REVISED BUCCI SUBDIVISION, RESUBDIVISION OF

APPLICATION NUMBER 11 DATE February 17, 2011
APPLICANT Revised Bucci Subdivision, Resubdivision of
REQUEST Subdivision

DETAIL SITE PLAN

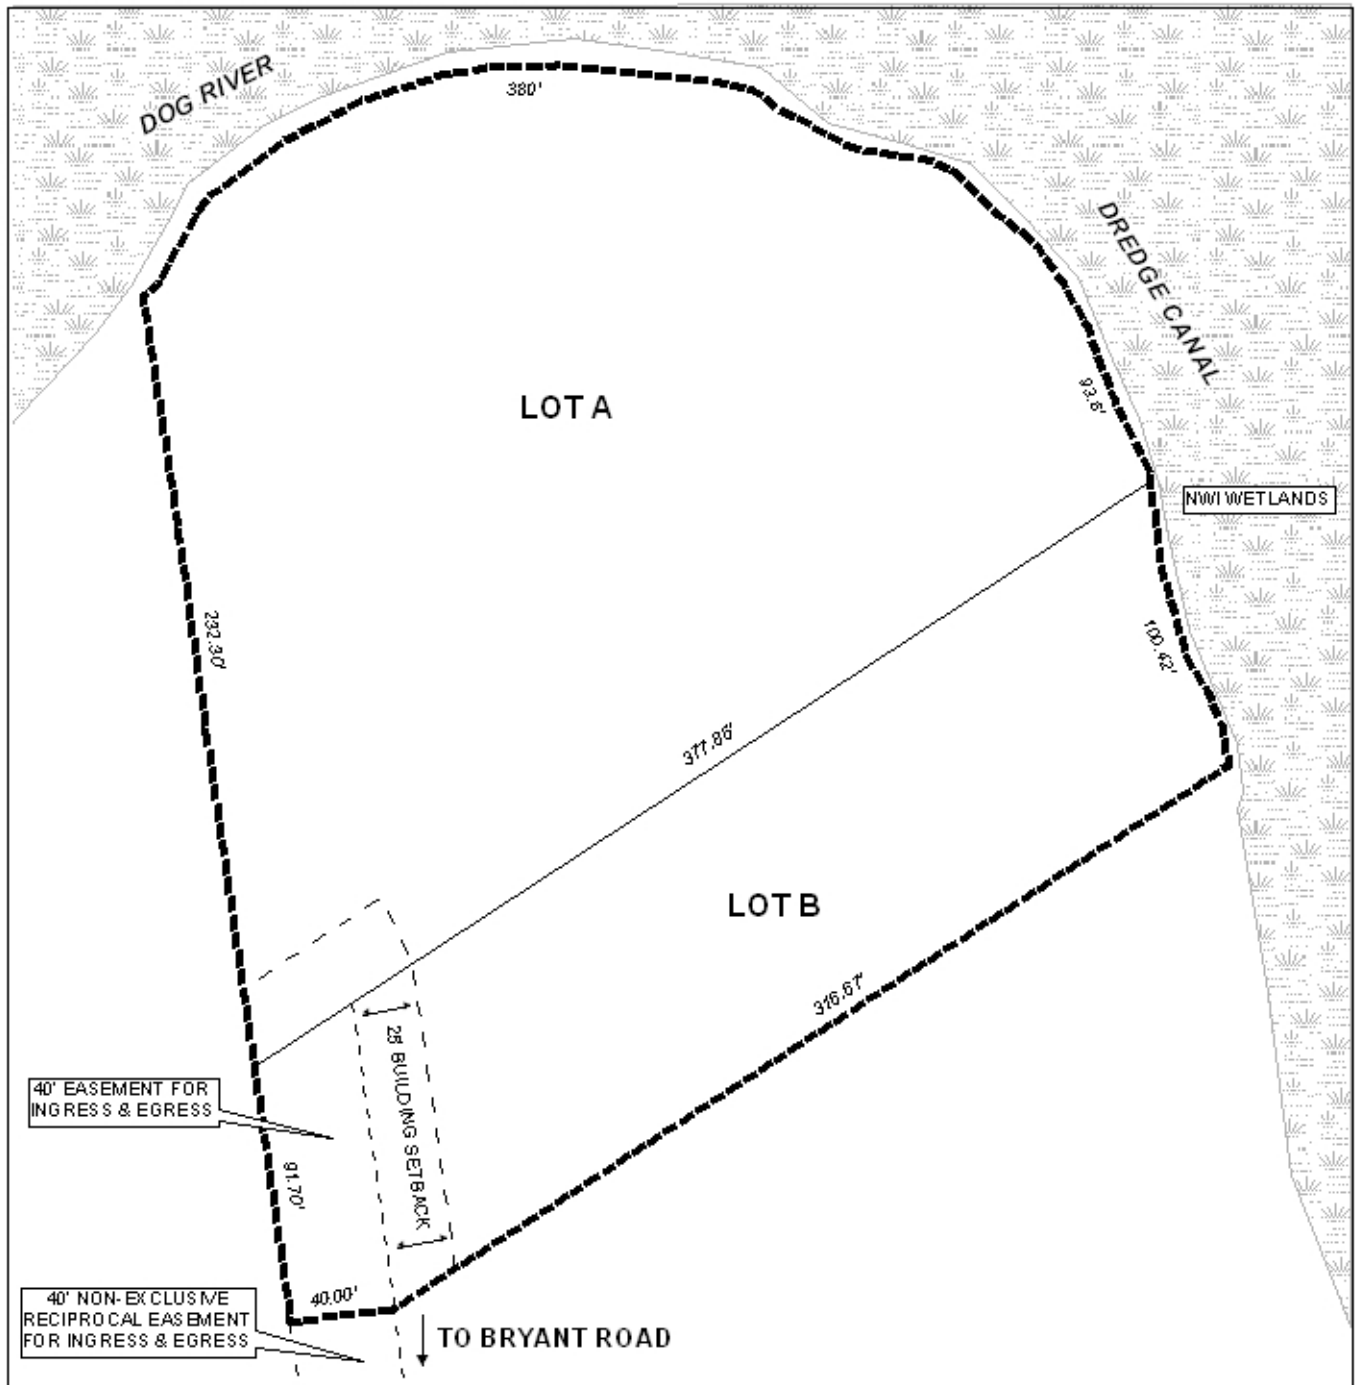
Each lot meets the minimum requirements of the Subdivision Regulations. However, the plat should be revised to label each lot with its size in both square feet and acres, or a table should be furnished on the final plat providing the same information. As on the preliminary plat, the 25'

minimum building setback line should be illustrated on the final plat as measured from the easement frontage on both lots.

- 2) labeling of each lot with its size in acres and square feet, or the furnishing of a table on the final plat providing the same information;
- 3) illustration of the 25' minimum building setback line on each lot as measured from the easement frontage;
